REMARKS/ARGUMENTS

This reply is responsive to an Office Action mailed on December 8, 2004. Claims 1-21 were pending in the application.

Application Number 10/650,263
Amendment Dated March 8, 2004
Reply to Office action of December 8, 2004
Annotated Sheet Showing Changes

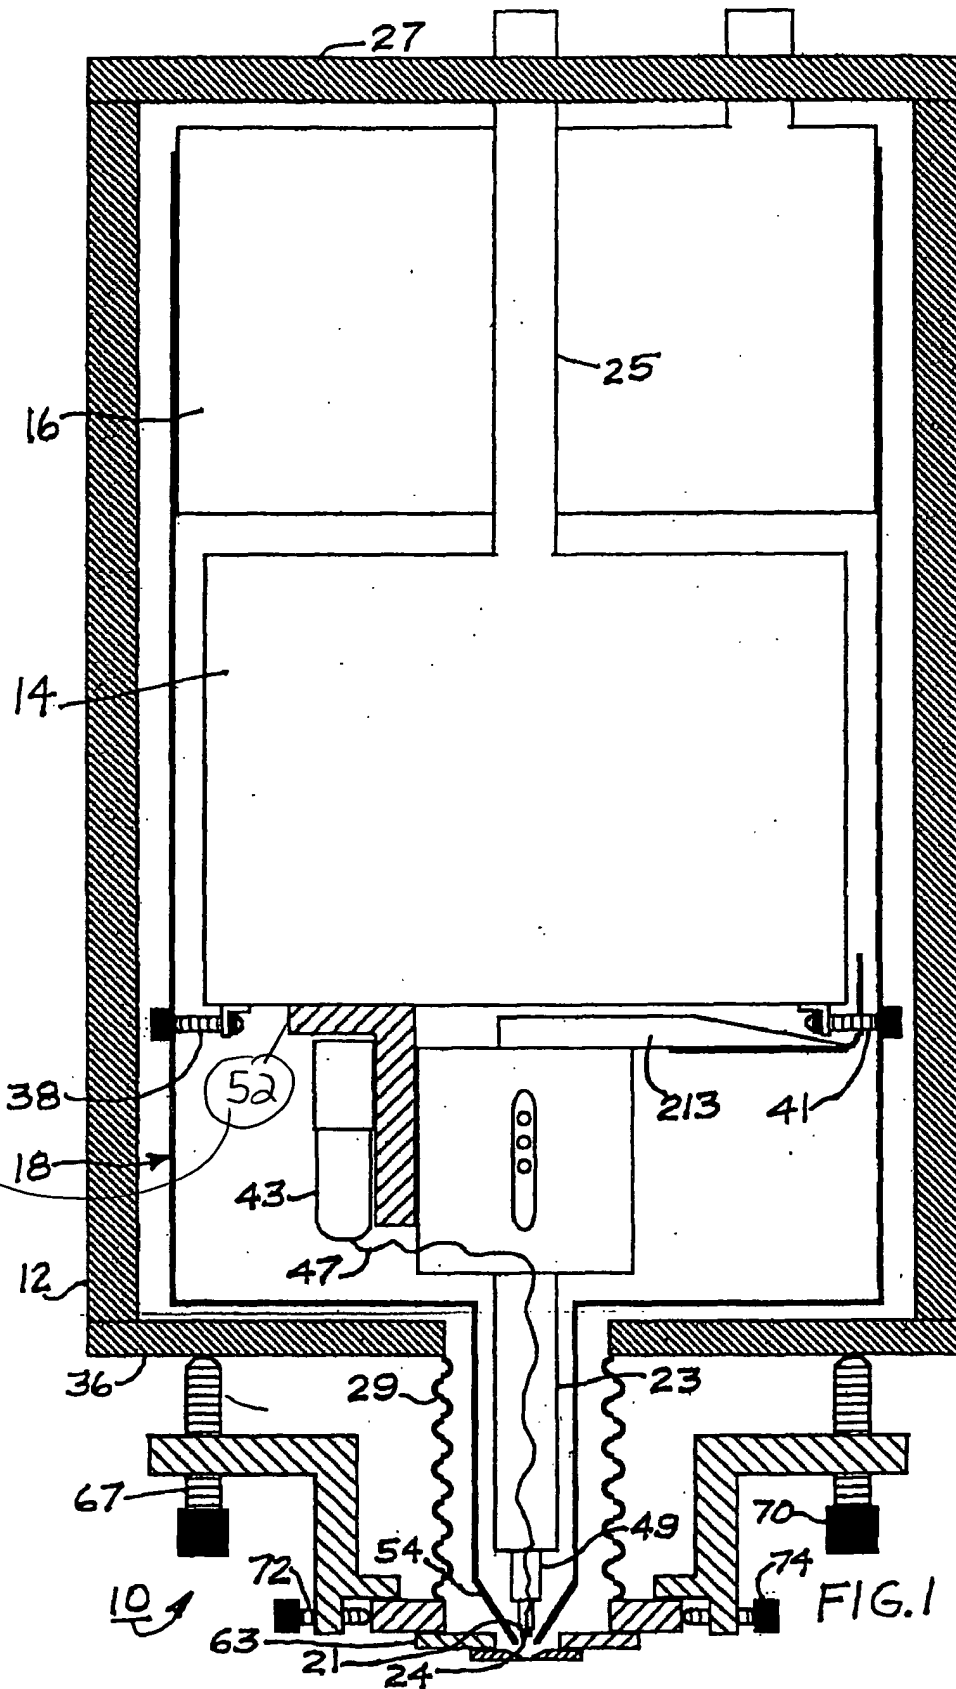
The drawings have been objected to as failing to comply with 37 CFR 1.84(p)(5) because they do not include reference signs mentioned in the description, namely the cold plate 52 and the motor 87.

Replacement sheets for Figure 1 and Figure 5 with an annotated sheet showing changes for these two figures have been provided. Figure 1 now shows the reference sign for the cold plate 52 and Figure 5 now shows the reference sign for the motor 87.

Element 52
added to the
drawings.
